Our ref: Q210286 Your ref: 21/03177/F

Axis J9, Phase 3

I write in response to your email dated 18 February 2022, which set out Officers' views on the proposals.

Figure 1.1 – South West Elevation of Unit 1 to 3 as submitted

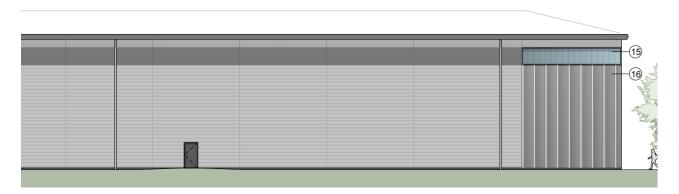
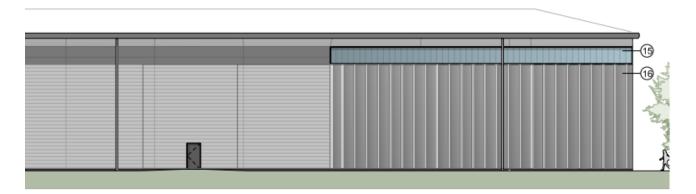
You requested that the rainscreen feature cladding and projecting fins along the southwestern elevation of Unit 1-3 be extended and the proposals have been updated in accordance with this suggestion (see Figure 1.1 and 1.2 for comparison).
